November 5, 2012

RE: GOODYEAR RIVERWALK
SEIBERLING STREET LANDFILL
SEIBERLING WAY
NOTICE OF VIOLATION

October 30, 2012 inspection

TITLE STORM AND SANITARY SEWERS - OVERALL MASTER OF AKRON PLANTS

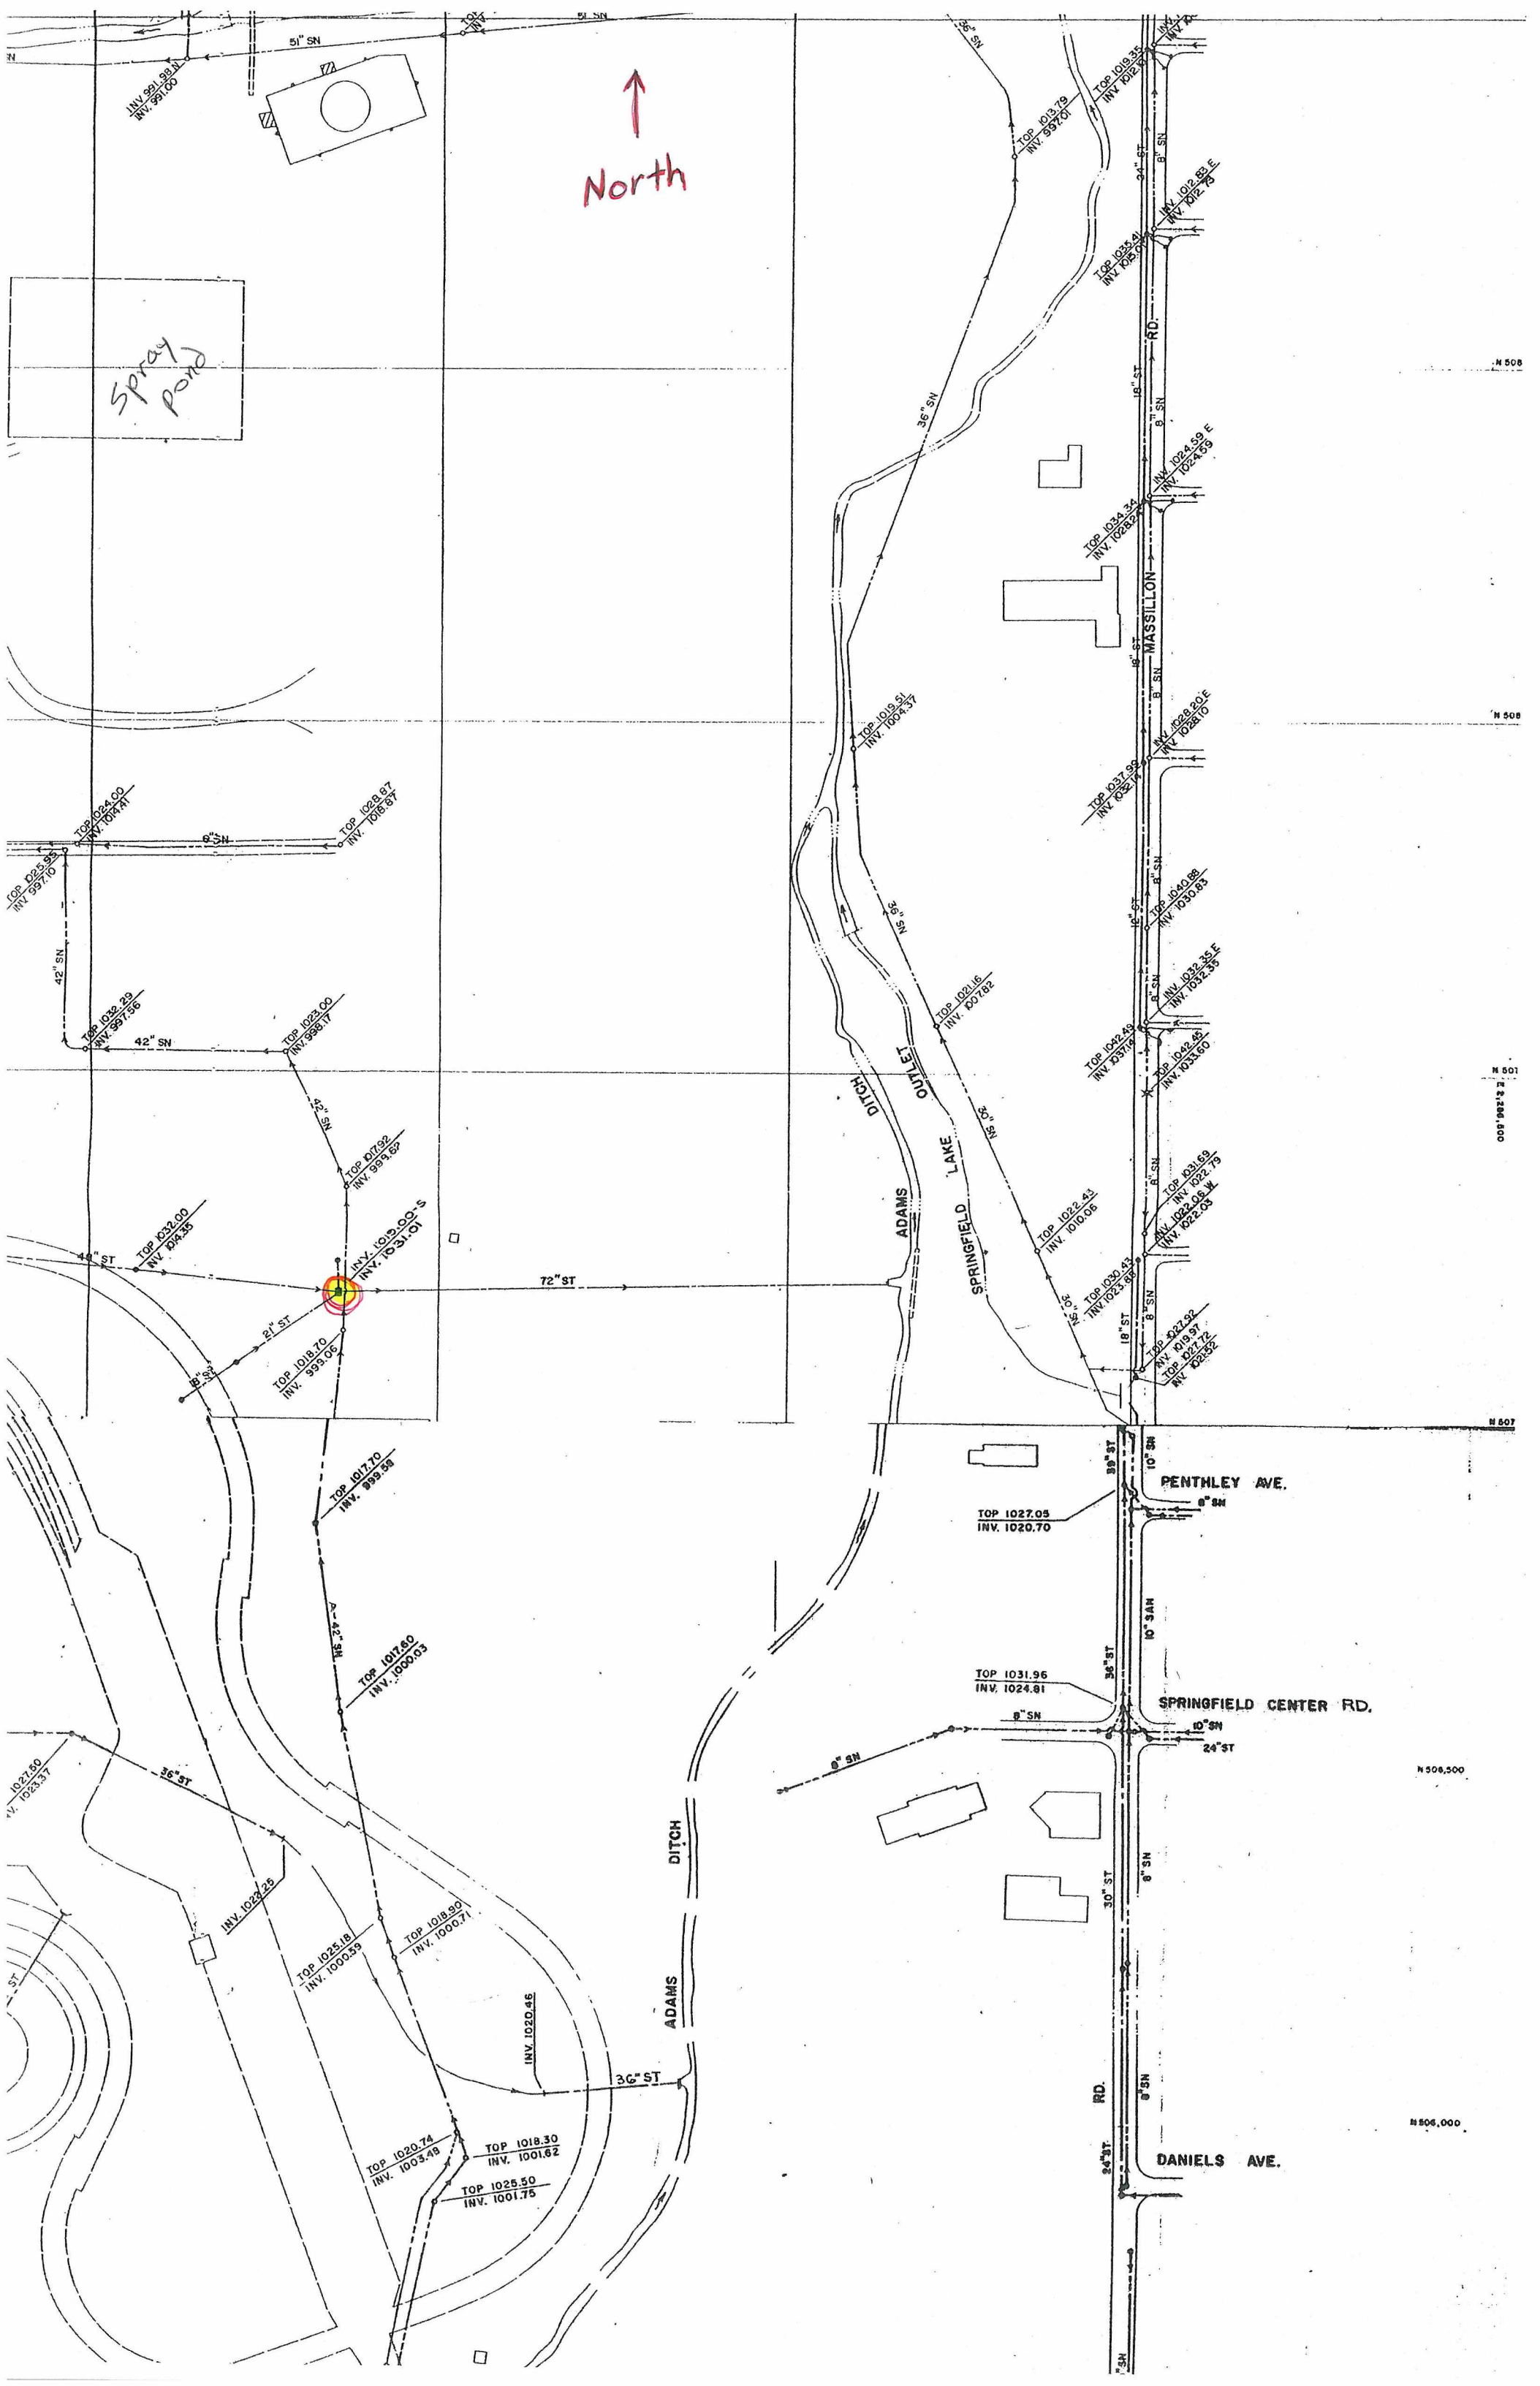
There were three unidentified manhole-like structures that were found during excavation of the roadway. It is unclear if these structures are storm sewers, dry wells, sanitary sewers, injection wells, etc. Please provide information on the unidentified structures, such as depth, type of sewer or well, possible tie-ins with other sewers. Please submit a proposed alteration to Exhibit 1 of the November 2011 Rule 13 authorization in accordance with Section VII of the authorization order. The proposed alteration shall include details as to how these three structures will be abandoned, including the following information: Excavated materials shall be replaced with low strength mortar grout or bentonite clay, any water collected from these structures should be considered leachate and should be properly

characterized and disposed of in accordance with ORC Chapter 6111. Attached is a section of a plan drawing showing sewers in the landfill area from 1982 that may be helpful. On the drawing "ST" stands for storm sewer.
